**HISTORIC PRESERVATION REVIEW BOARD
STAFF REPORT AND RECOMMENDATION**

Landmark/District: **1644-1662 Park Road NW/Mount Pleasant Historic District**
Address: **1656-1658 Park Road NW** (x) Agenda
Meeting Date: **July 25, 2019** (x) Alteration
Case Number: **19-402** (x) Permit

*Above: The houses' front yard prior to the recent paving/repaving.
Below: The front yard "after."*

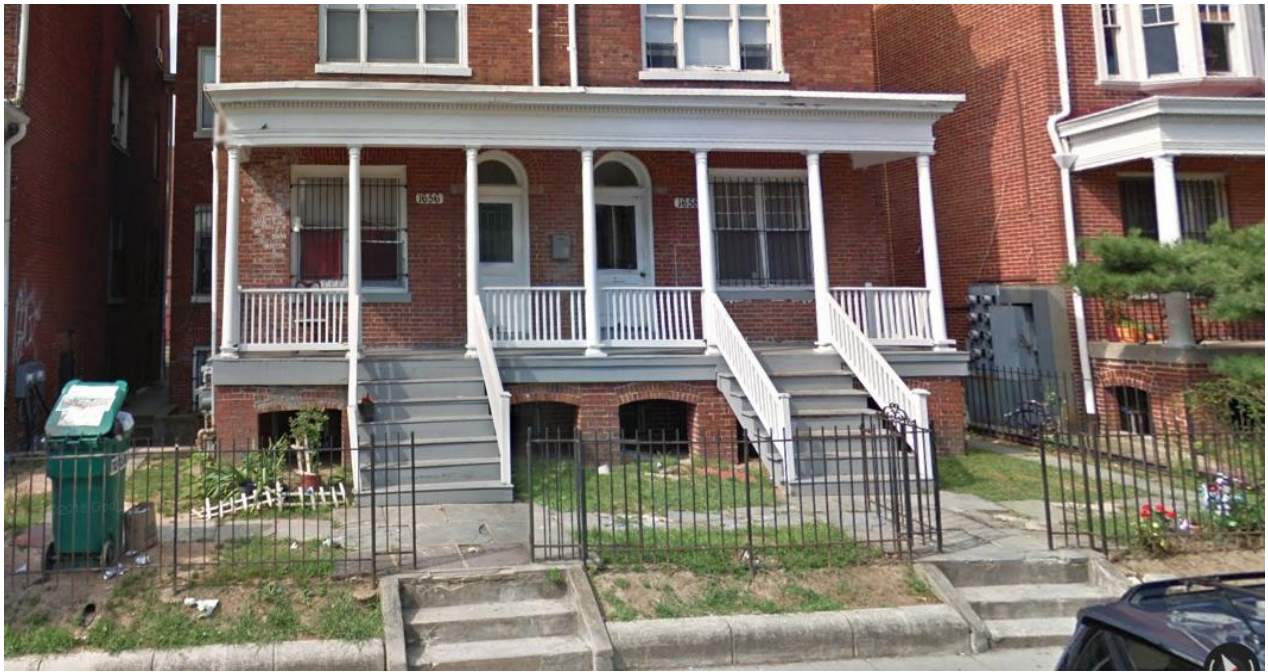
The front had straight-run concrete lead walks and steps, bisecting grassed yards, consistent with the rest of the row. Previous owners, rather than repairing or replacing the century-old walks, stuck flagstones over them and installed similar stepping stones as a walk around the buildings.

Now, nearly the entire surface of the yard has been covered with flagstones, limiting the green areas to planters at the public sidewalk (see photos, page 5). This work requires a public-space permit and would not have been supported by HPO, because the Board's policy has long been to

- 1. true slate be restored to at least the front roof—to match the color, cut, dimensions and coursing/exposure of the original slates; and*
- 2. that the removal of the new paving from the front yard be carried out under a separate public-space permit, with the paving to be limited to the extent seen in the Google Streetview photos dated September 2007 through July 2017, namely, on the lead walks and a narrow walk around the houses.⁴*
